Task Force 3 – Testing Procedures Meeting Notes – Stuttgart – Nov. 4, 2019

Fig : Container

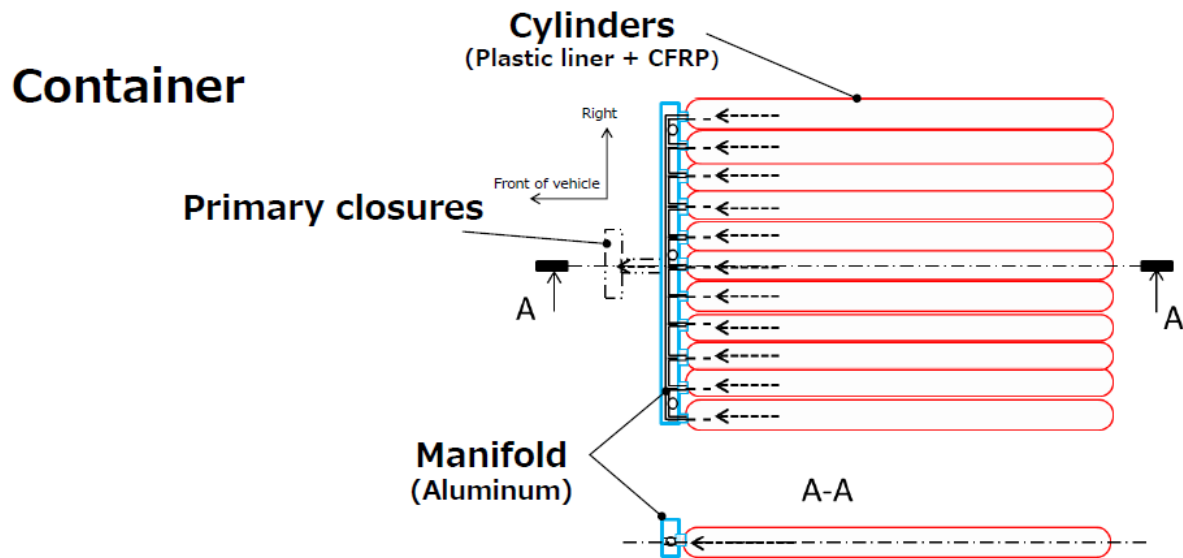
- Some of the issues with the TMC proposal (and by extension, proposals submitted by Linamar but not discussed), included:
  - Manifolding creates an issue with one container/one OTV requirement, so a new definition for container was proposed

- Elimination of 25mm flaw because straps not employed opens the door for neck mount containers to be exempt – also misunderstanding of the reason for the 25mm flaw

- Vibration not considered
- TF 3 asked TMC and Linamar to present detailed proposals for changes to test procedures to accommodate conformable containers (considering all possible vulnerabilities)
